# SITE DEVELOPMENT PLANS

## LISCIOTTI DEVELOPMENT CORP.

LOCATION OF SITE:  
30 WILTON ROAD, TOWN OF MILFORD  
HILLSBOROUGH COUNTY, NEW HAMPSHIRE  
MAP #6, LOT #14

**DOLLAR  
GENERAL  
MILFORD,  
NH**

COVER SHEET

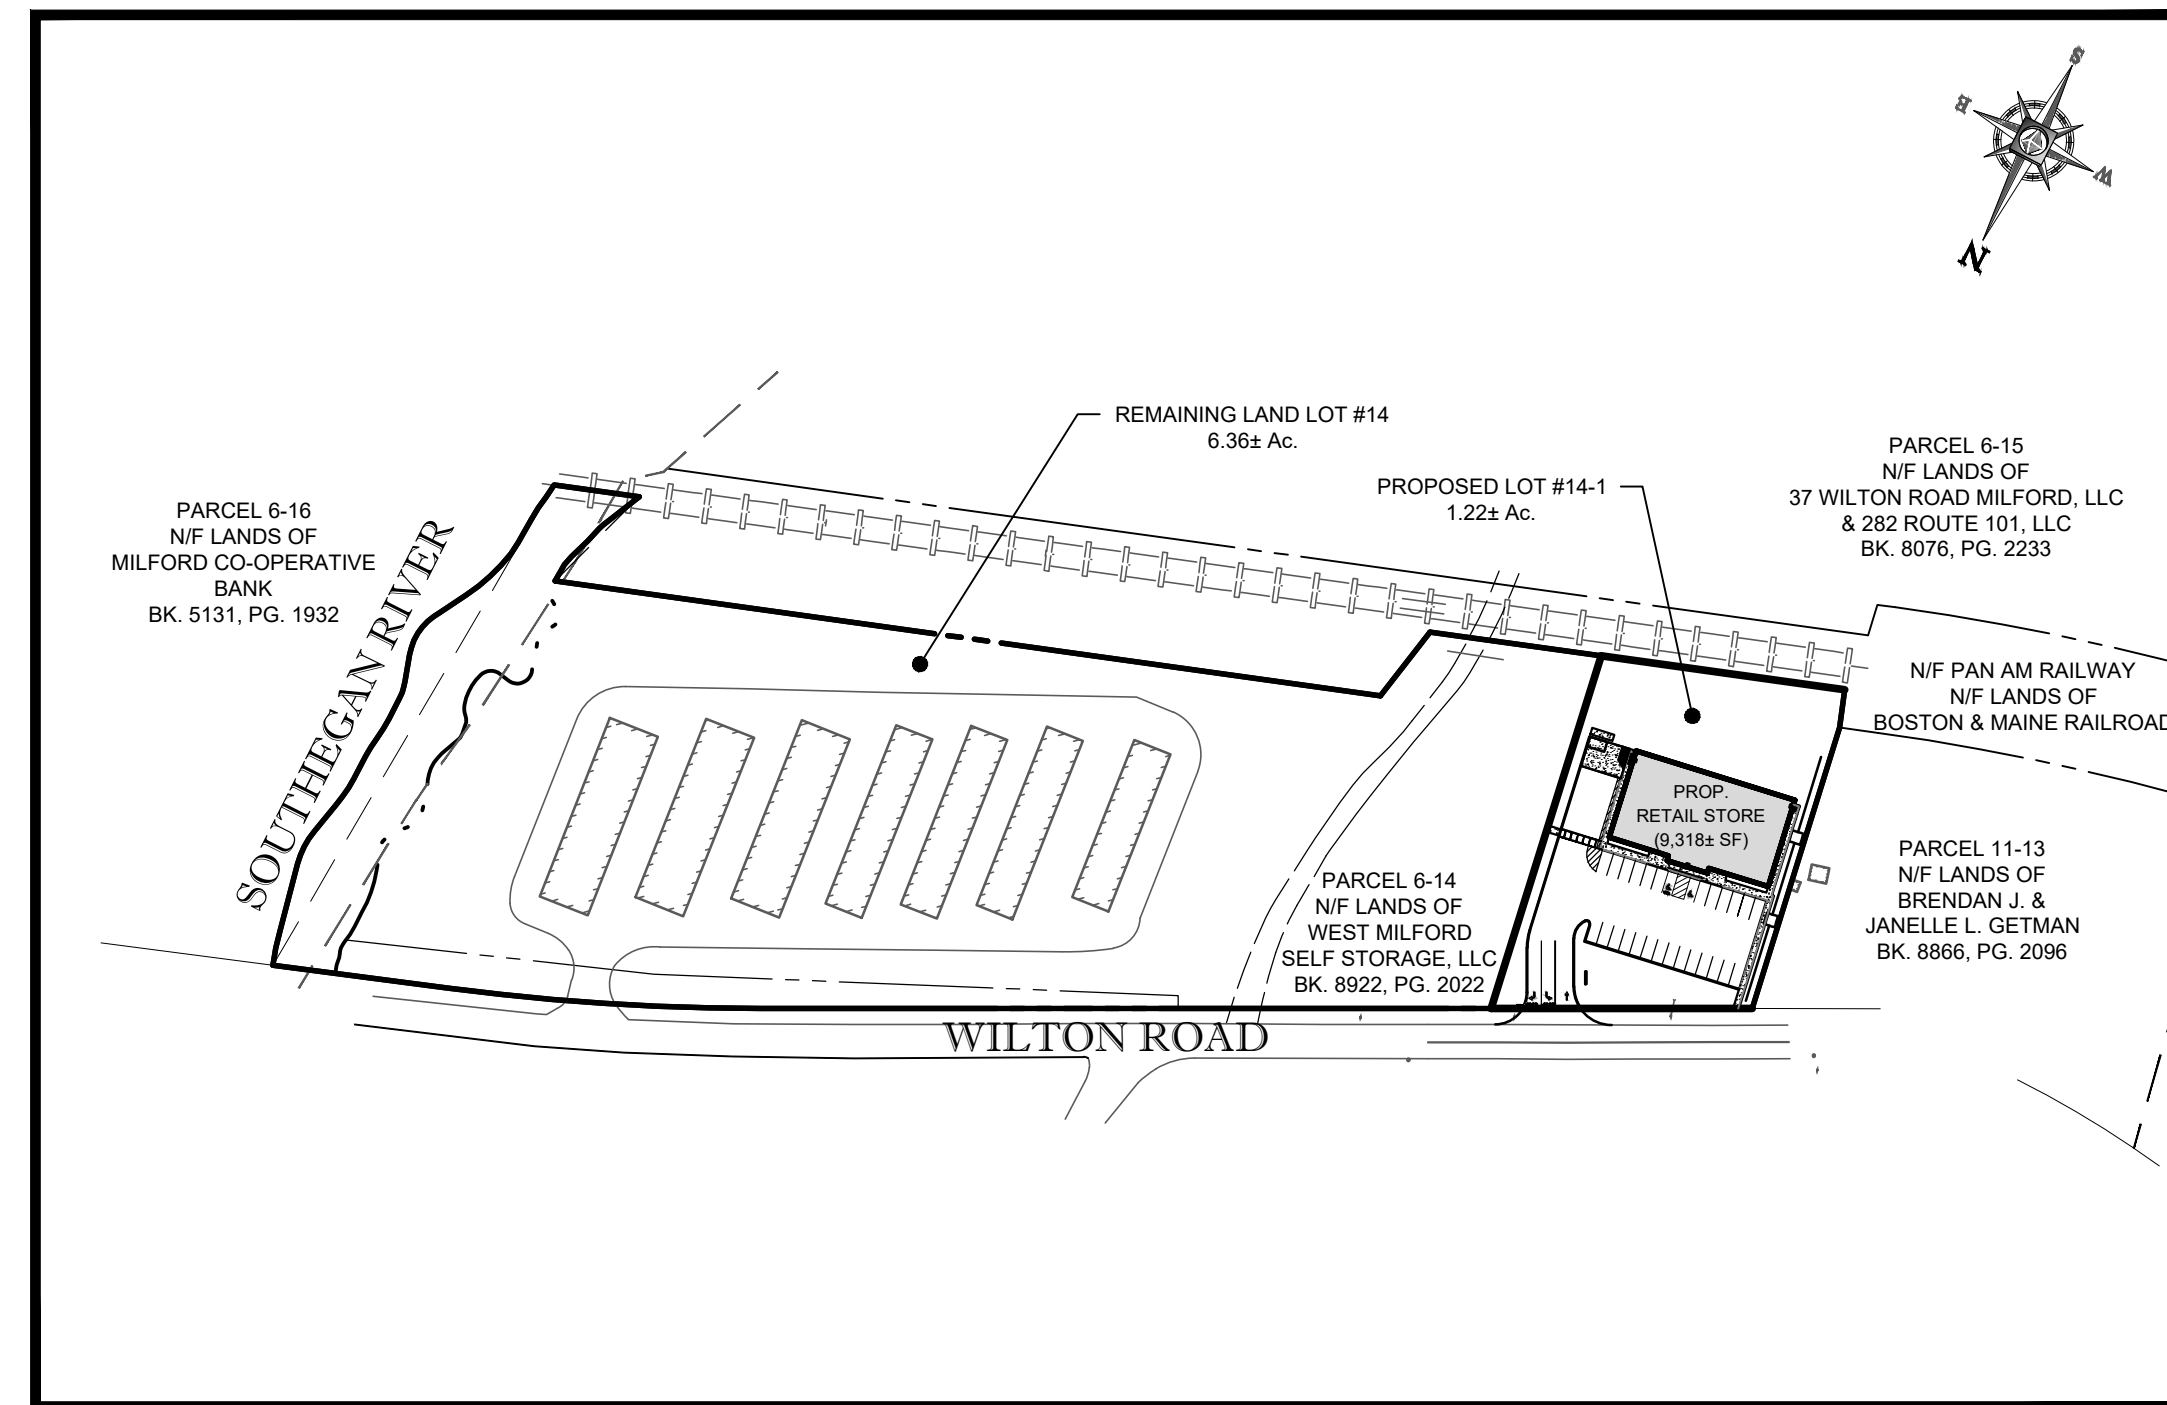
**Comment 1:** *Sheet 1. Please revise the plan to include signature blocks for the Planning Board and Property Owner and resubmit.*

**Comment 2:** *Sheet 1. Waiver Requests. Recommend incorporating the Waiver Requests Block into a general Notes block. Further, please add the following notes:*

**Comment 3:** *Sheet 1. Please revise the plans to include a Reference Plan block and plans used to compile the submitted site plan.*

**Response 1:** **Planning Board and Property Owner signature blocks have been included on Sheet 1 of the enclosed Site Development Plans.**

**Response 2:** **The requested notation has been included on Sheet 1 of the enclosed Site Development Plans.**

**Response 3:** **A Reference Plan block has been included on Sheet 1 of the enclosed Site Development Plans.**

SHEET TITLE:  
**SITE PLAN**

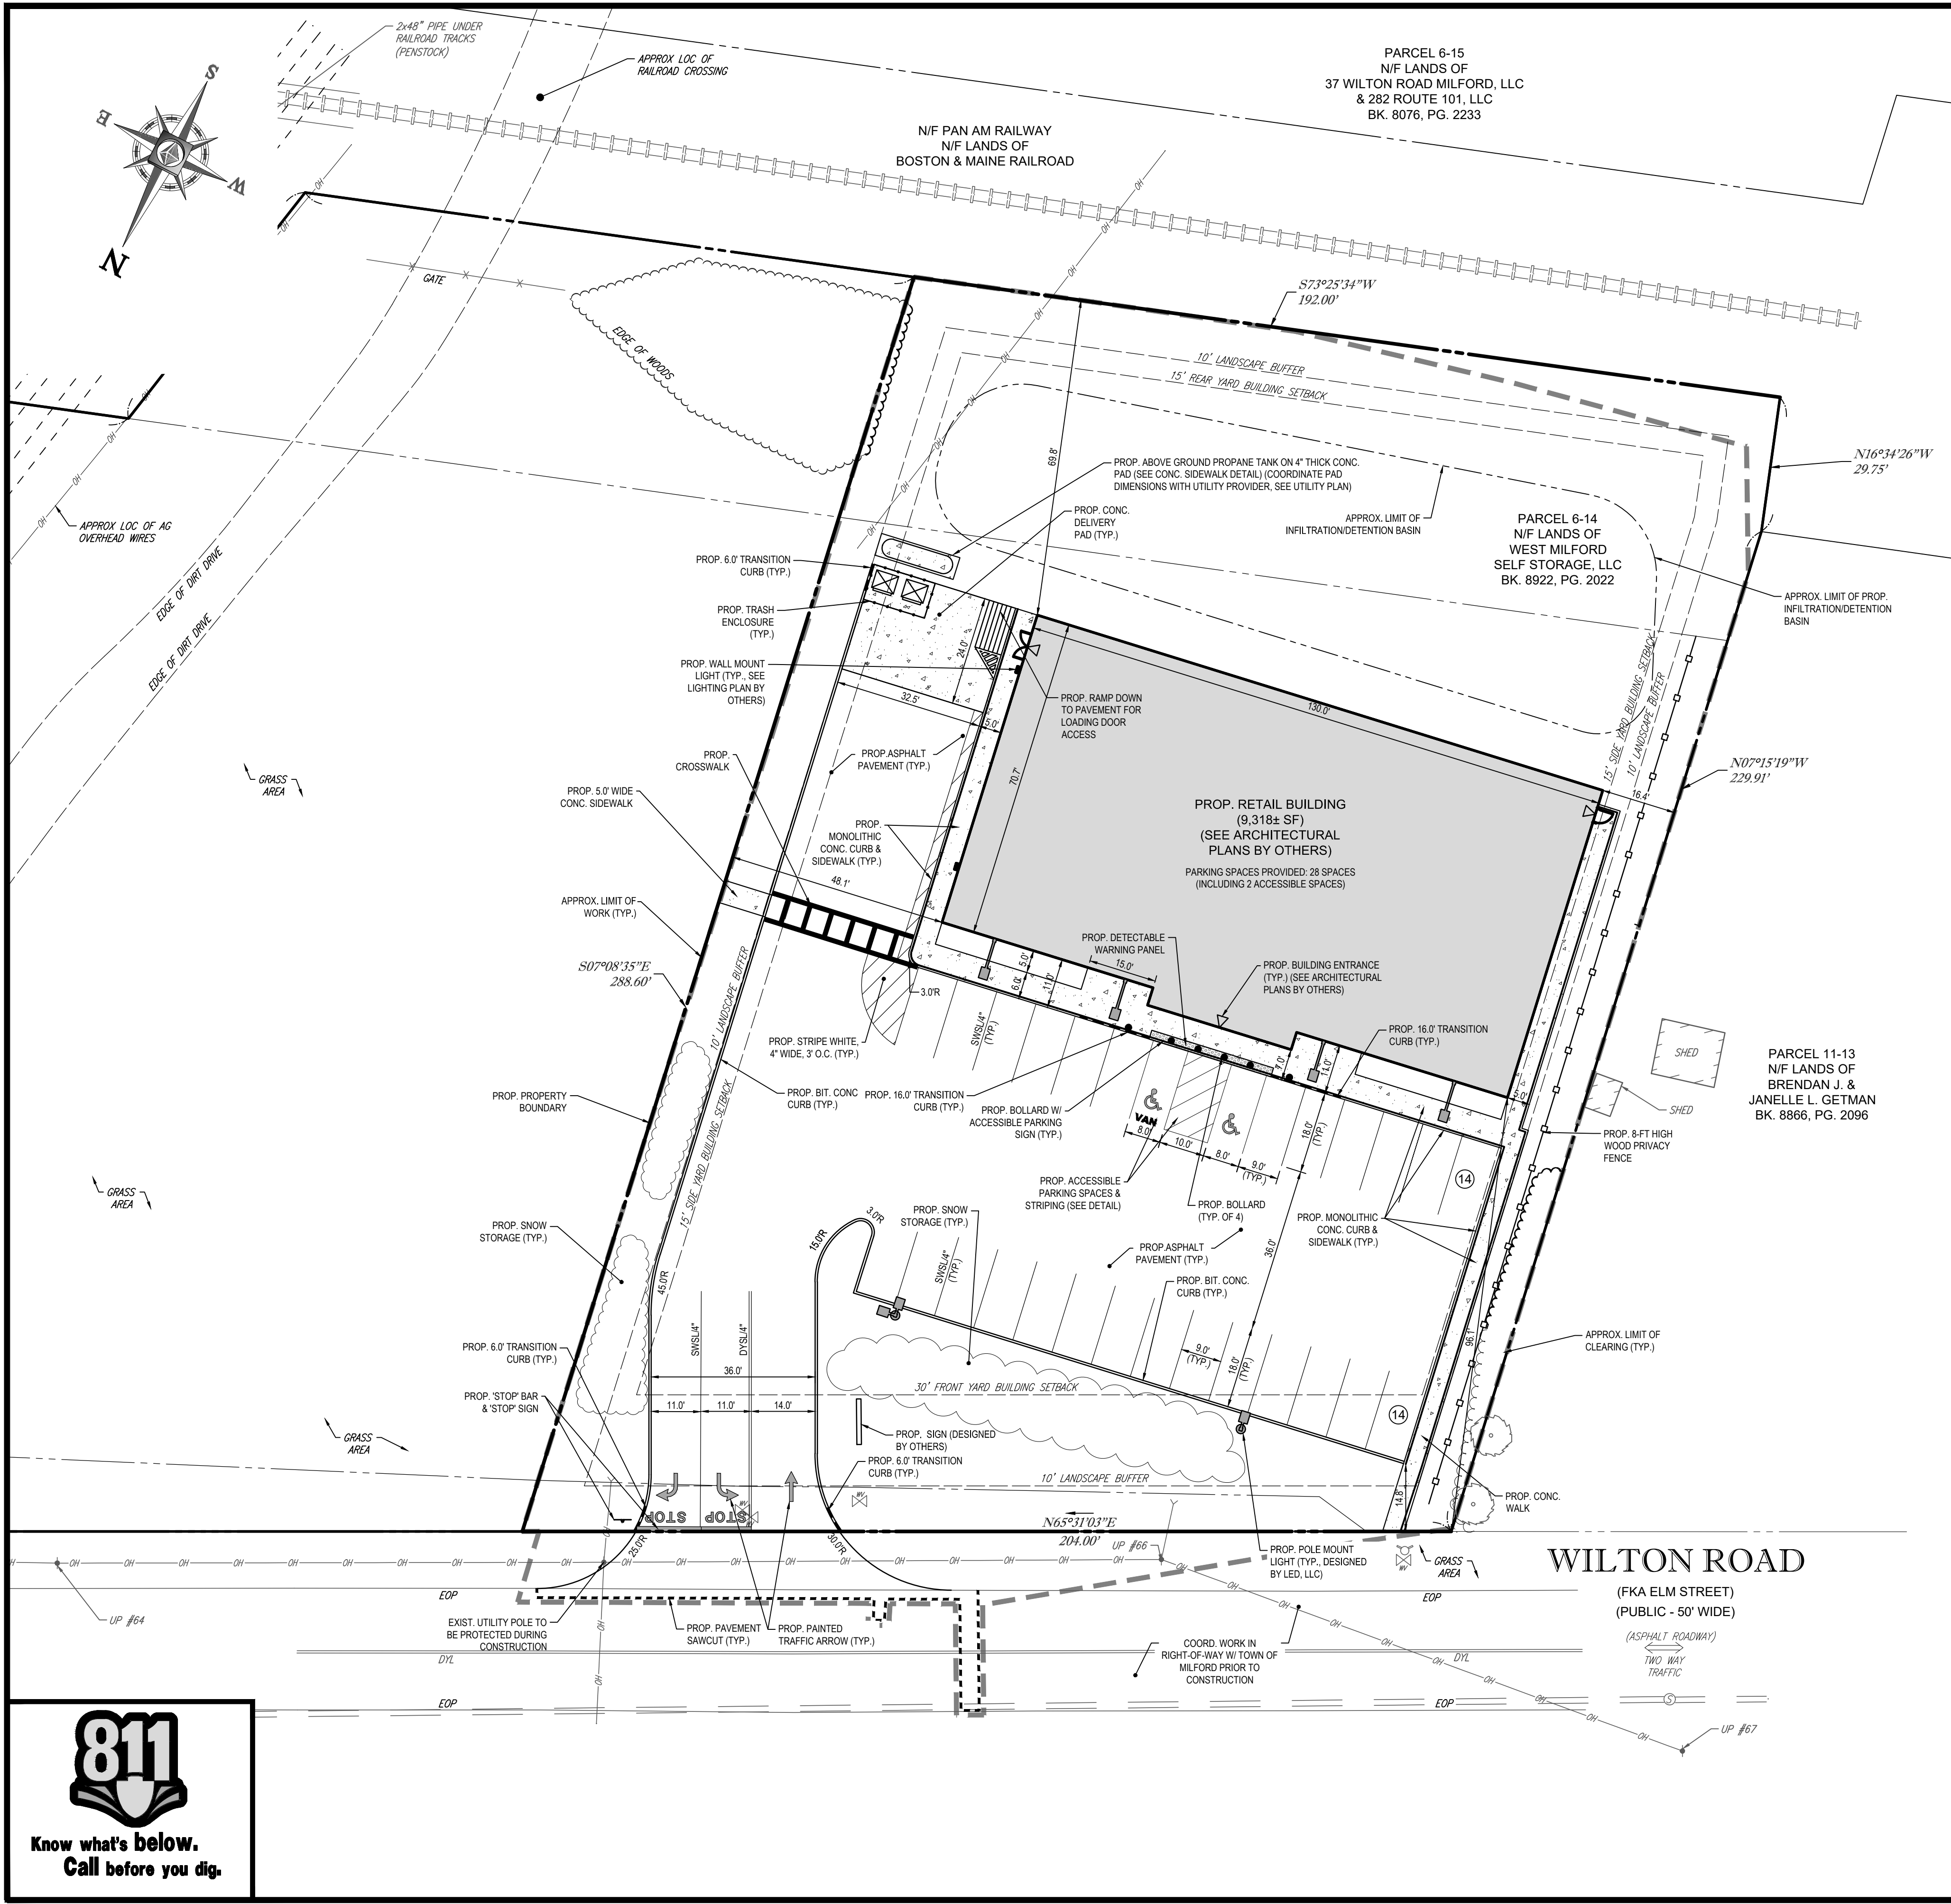
**Comment 4:** *Sheet 3, Zoning Analysis Table. The project area is located on an undeveloped portion of the parent lot, Map 6, Lot 14. Please confirm the existing impervious coverage calculation of 31.8% and clarify if said percentage represents the parent lot, Map 6, Lot 14 or the proposed subdivided lot, Map 6, Lot 14-1. Similarly, please explain the 54.3% proposed impervious coverage area.*

**Comment 5:** *Sheet 4, Site Plan, Zoning Analysis Table. The plan states that the maximum height of the building will be 18'. However, the submitted elevations show that the building height will be 30' 4". Please explain and revise the plan accordingly.*

*Comment 6:* Sheet 4, Zoning Analysis Table. Please revise the parking calculation by separating the retail use and warehouse/storage area within the building in accordance with Section 6.05.4 of the Development Regulations.

*Comment 7:* Sheet 4. Proposed Signage. Please include the proposed design, construction, and engineering details associate with the monument sign, directional signage, and wall signage. Recommended placement of information on Sheet 13.

*Comment 8:* Sheet 4. Snow Storage. The plan shows a snow storage location along the front and east side perimeters of the subdivided lot. Sheet 4 also contains a note stating that snow shall be removed to an off-site location..... Please clarify and describe the anticipated process for snow removal. It is recommended that the snow removal company be a certified Green Snow Professional.

*Comment 9:* Sheets 4 and 9. The plan displays an 8' tall fence extending along on the western property border to the southwest corner of the building. It is recommended that the fence be extended to the property line of the residential abutter to provide further visual mitigation of the building and improve the safety/security between the two properties.

**Response 4:** **The Zoning Analysis Table has been updated to be reflective of information for only the land area associated with proposed Lot 14-1, as shown on Sheet 4 of the enclosed Site Development Plans.**

**Response 9:** The proposed eight (8) foot high fence has been extended an additional thirty-five (35±) feet towards the rear of the parcel to the limit of the existing easement, as shown on Sheet 4 of the enclosed Site Development Plans. The beneficiary of the existing easement, Pan

SHEET TITLE:  
**GRADING & DRAINAGE PLAN**

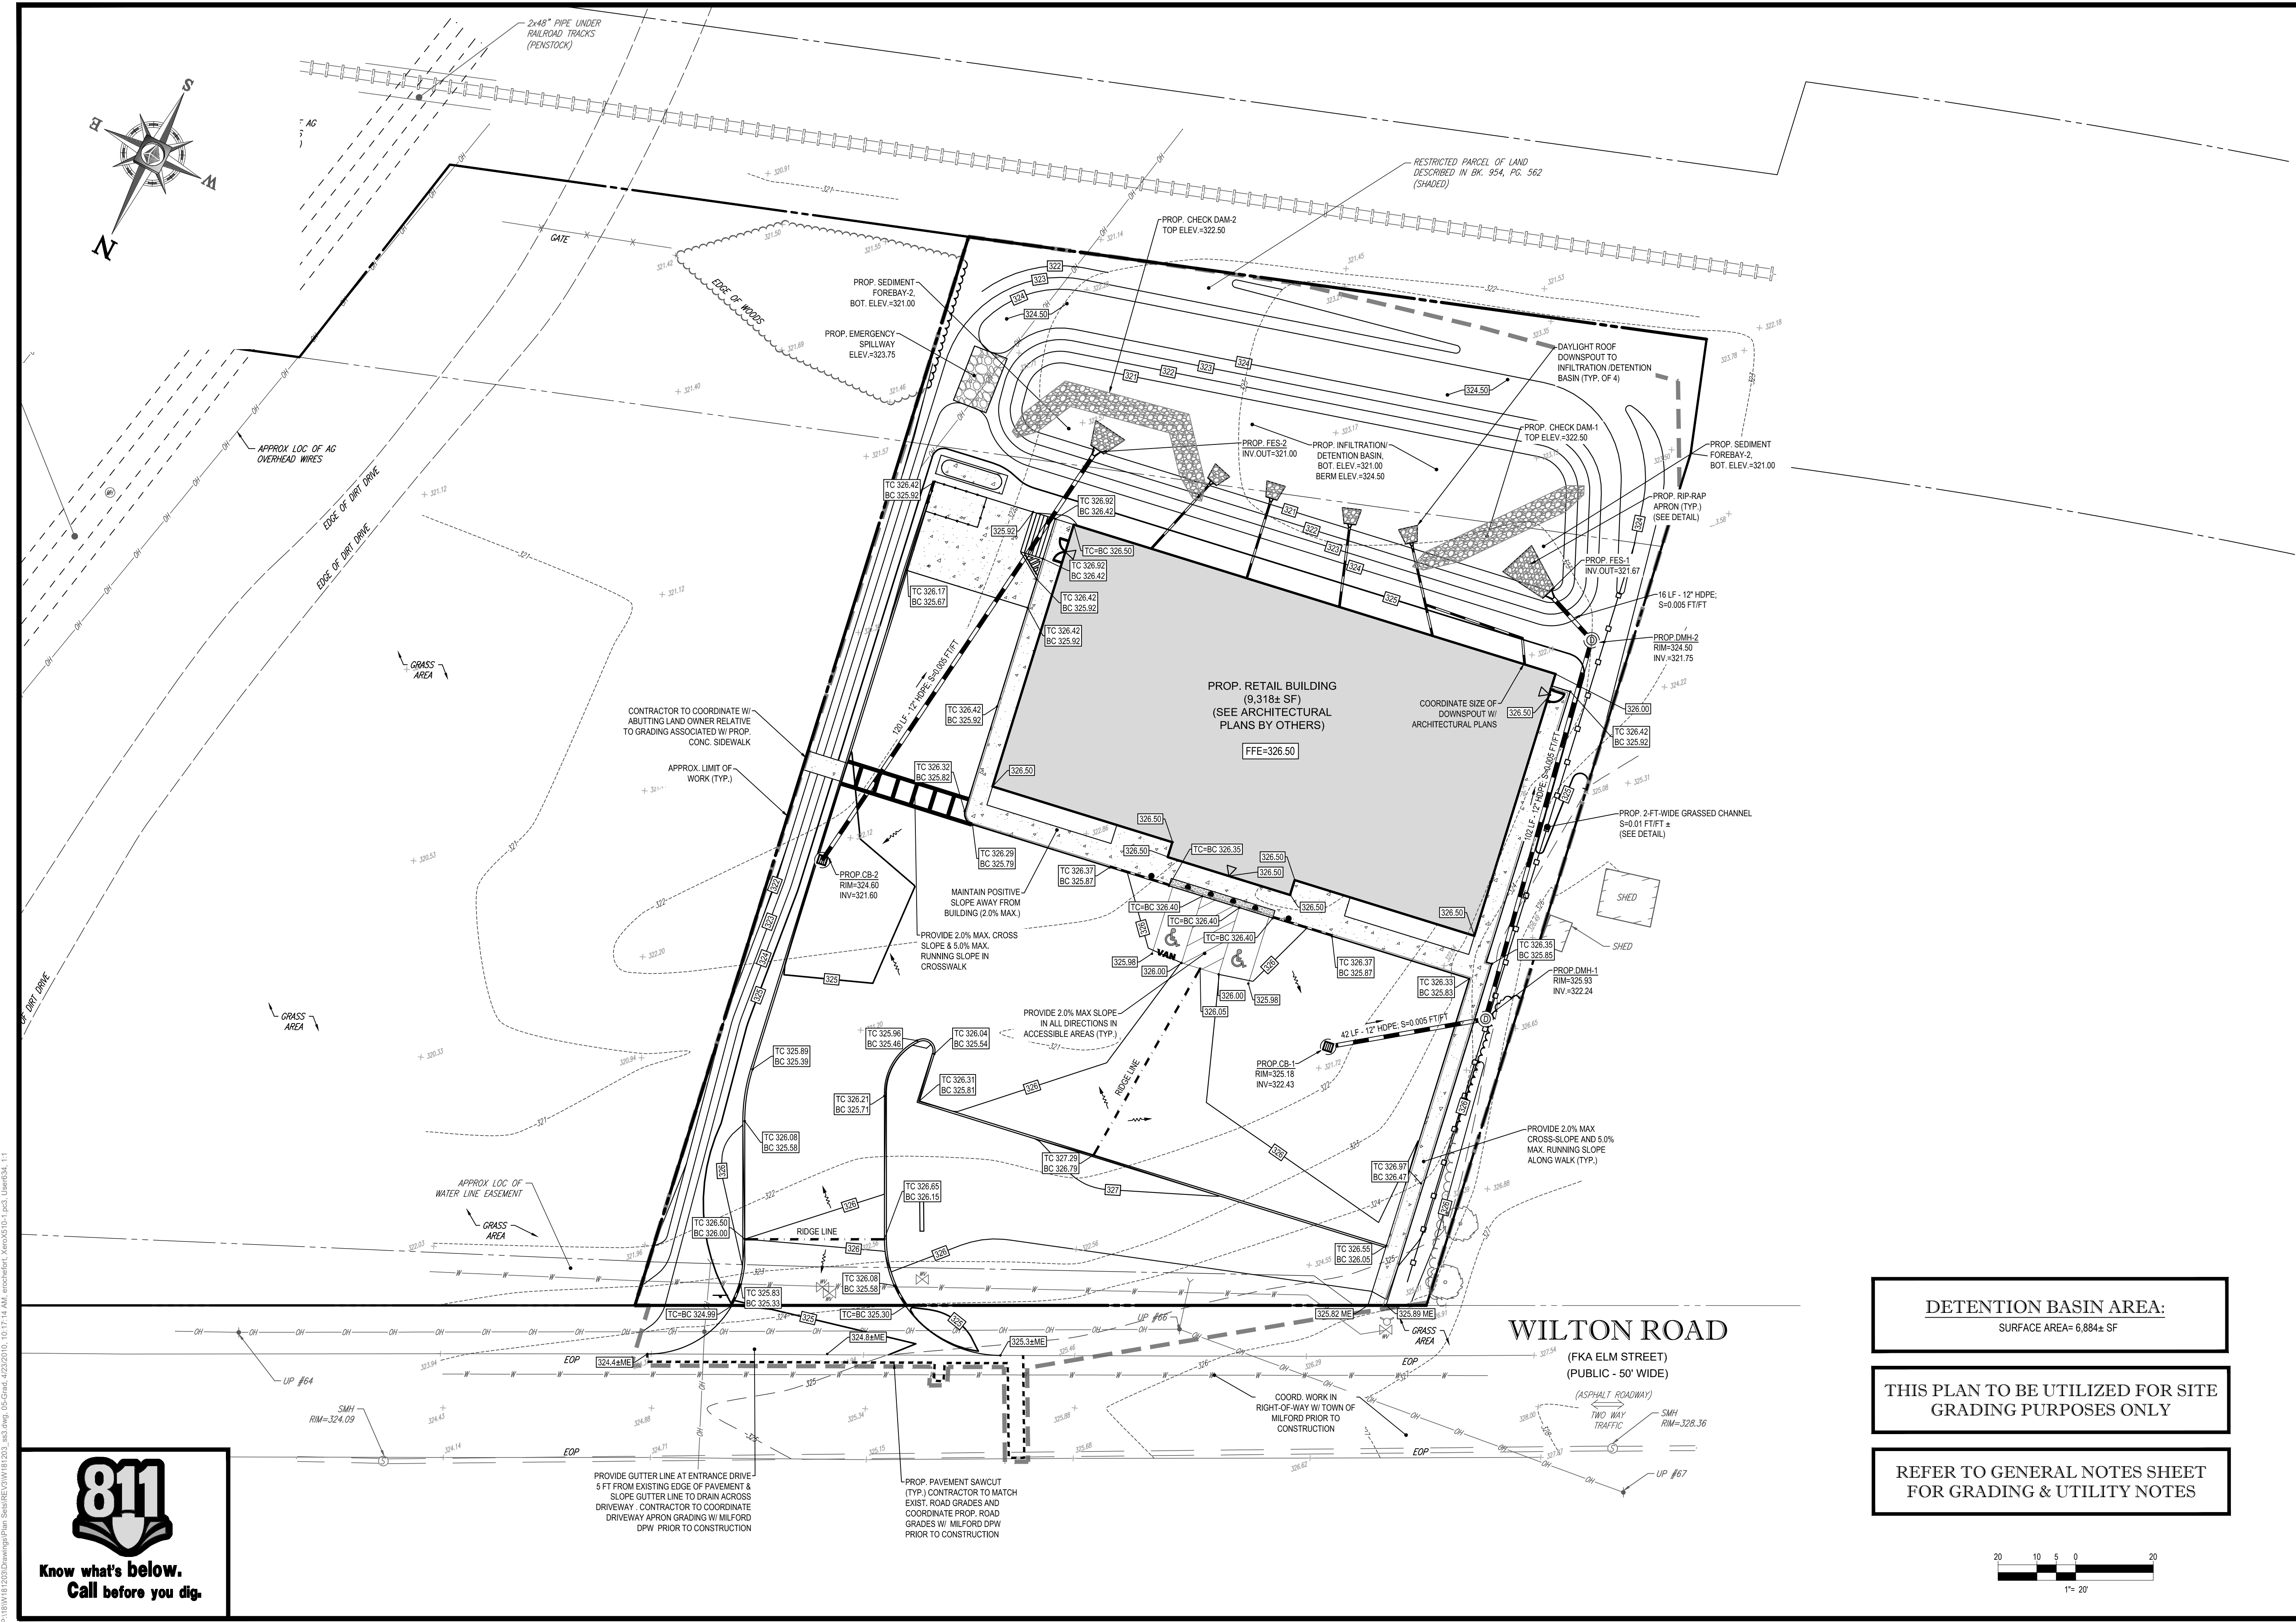
**Comment 10:** *Sheet 5. Please explain if LID practices were considered as part of the drainage/stormwater and landscape design. More specifically it would appear that opportunities exist to utilize portions of the landscaped areas for treatment and infiltration of stormwater. In addition, were there considerations to design a functional raingarden in lieu of the proposed 3 foot deep detention basin?*
